Landscape Referral Response

Application Number:	DA2021/1522
Date:	20/12/2021
Responsible Officer:	Adam Mitchell
Land to be developed (Address):	Lot C DP 381427 , 189 Riverview Road AVALON BEACH NSW 2107 Lot LIC 567410 , 189 Riverview Road AVALON BEACH NSW 2107

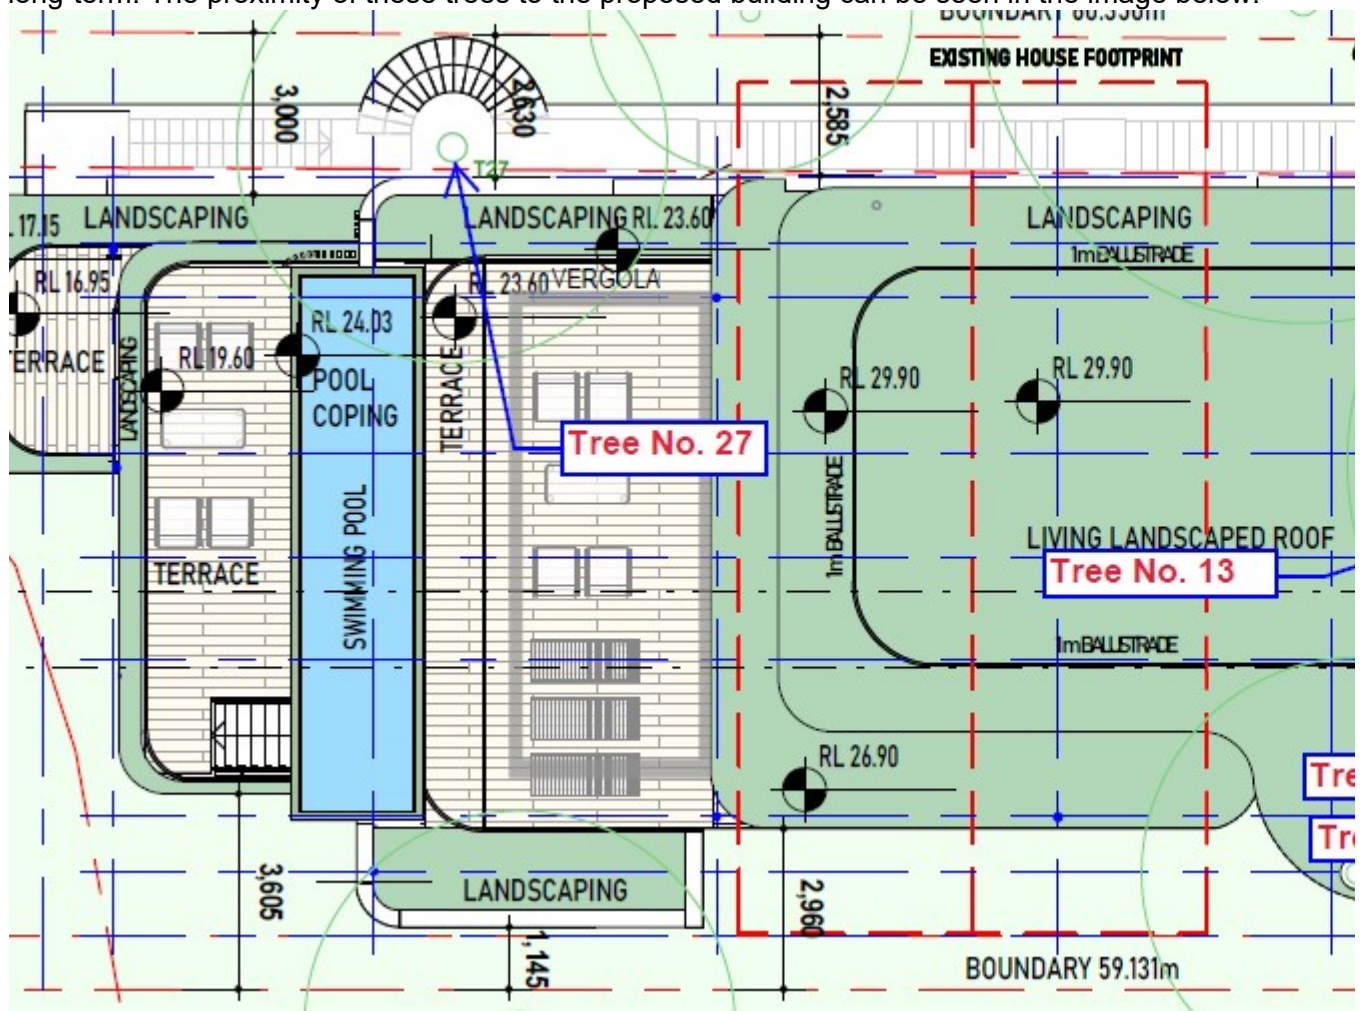
The two most significant trees located within the site, identified as Trees No. 13 and 27, have now been retained, with a number of tree root investigations taking place to determine the likely impacts of proposed works on existing root structures. Although this is seen as a positive, and it is clear work has been done to retain these trees, concern is still raised as these trees, in addition to Trees No. 7 and 8, fall within 2 metres of the proposed building. Should the plans be approved with the current layout, Trees No. 7, 8, 13 and 27 may all be removed without approval under the tree removal provisions outlined in control B4.22. The implications of this are significant as the total number of trees likely to be removed increases, including the two most value, biodiversity rich trees within the site. For this reason, it is recommended that further design alterations be made, ensuring that proposed works are at least 2 metres clear of proposed works to not only minimise impacts but also ensure they are retained in the long-term. The proximity of these trees to the proposed building can be seen in the image below:

Required tree root investigation location for Tree No. 13.

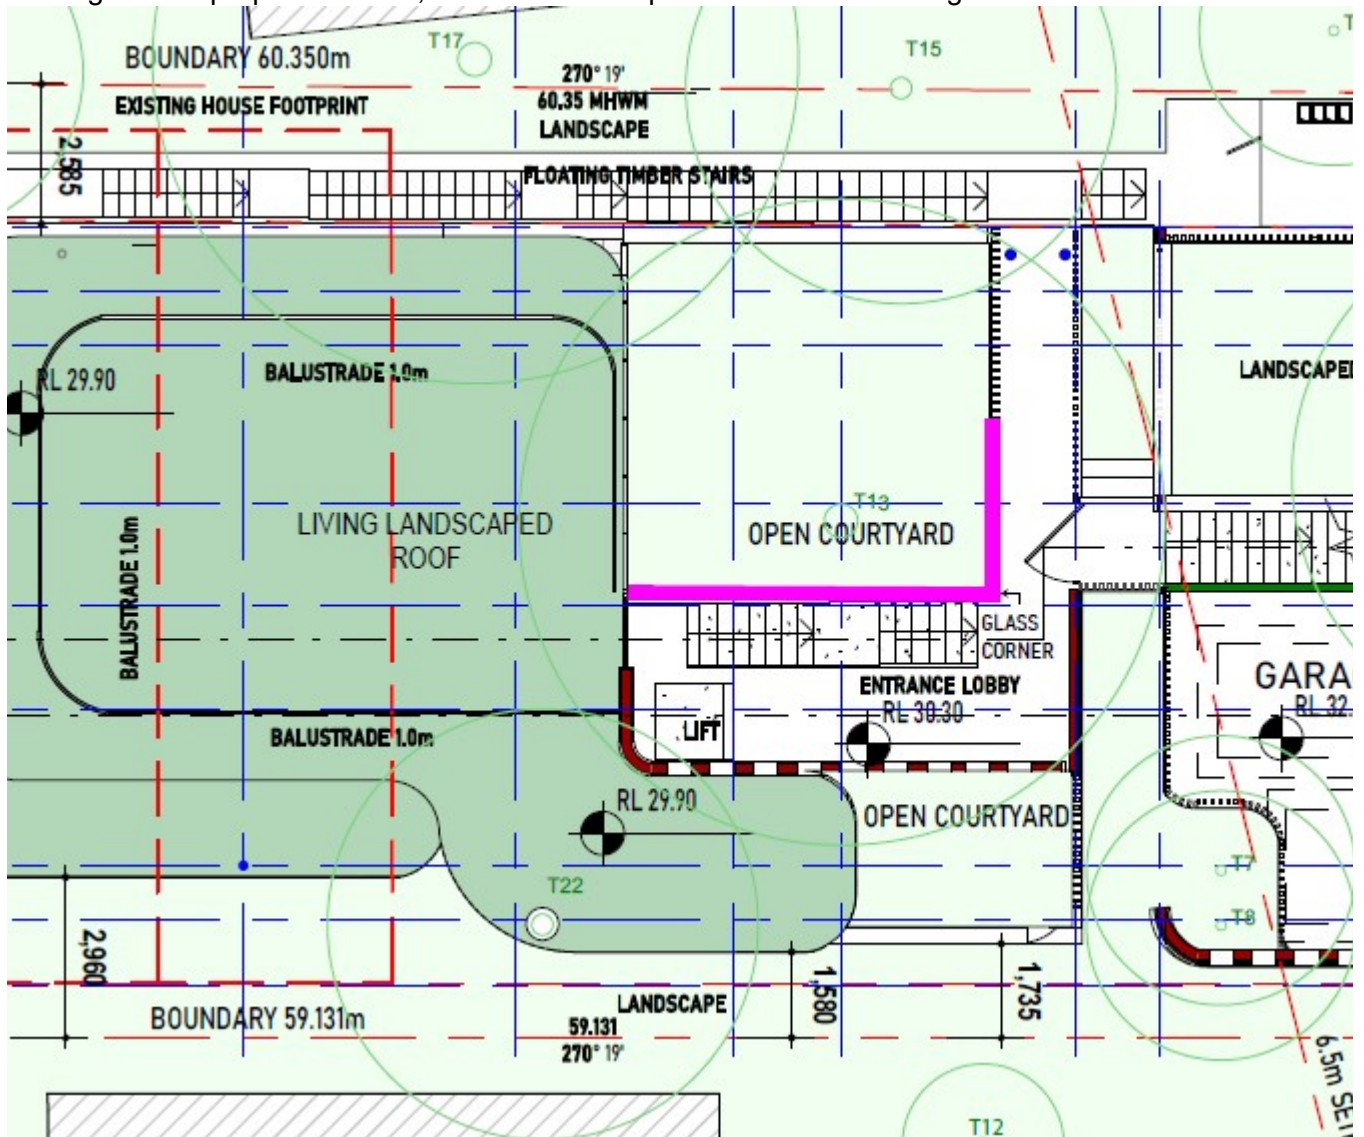
It is noted tree root investigations have taken place adjacent to Trees No. 13 and 27; however, concern is raised as these tree root investigations do not appear to have been completed on the edge of proposed works. Hence, these investigations do not provide an accurate depiction of the existing roots and what is likely to be impacted by the proposed works. In order to ensure proposed works do not impact significant roots of these two trees, it is recommended that additional tree root investigations

take place in the locations as depicted by the PINK line in the below images. Should design alterations be made to ensure greater clearance from these trees, the tree root investigations should take place on the edge of the proposed works, similar to that depicted in the below images:

In light of the above concerns, the landscape component is therefore not currently supported. It is recommended that an amended Arboricultural Impact Assessment be provided detailing the likely impacts of proposed works on Trees No. 4, 5, 7 and 8, with site specific tree protection measures recommended to ensure these trees are successfully retained and adequately protected. Should this investigation find proposed works are to have TPZ encroachments greater than 10% or any SRZ impact, further tree root investigations are required in accordance with AS4970-2009, specifically Clause 3.3.3 Major Encroachment. Additionally, it is recommended that an alternative design layout be sought ensuring that proposed buildings are located at least 2 metres from trees to be retained. This is particularly important for Trees No. 13 and 27. Following this, additional tree root investigations are required to take place in the locations depicted in the above images, or on the edge of proposed works. Should these investigations determine no significant roots are found and no detrimental impacts on these trees is likely, the landscape component of the proposal could be supported subject to conditions of consent.
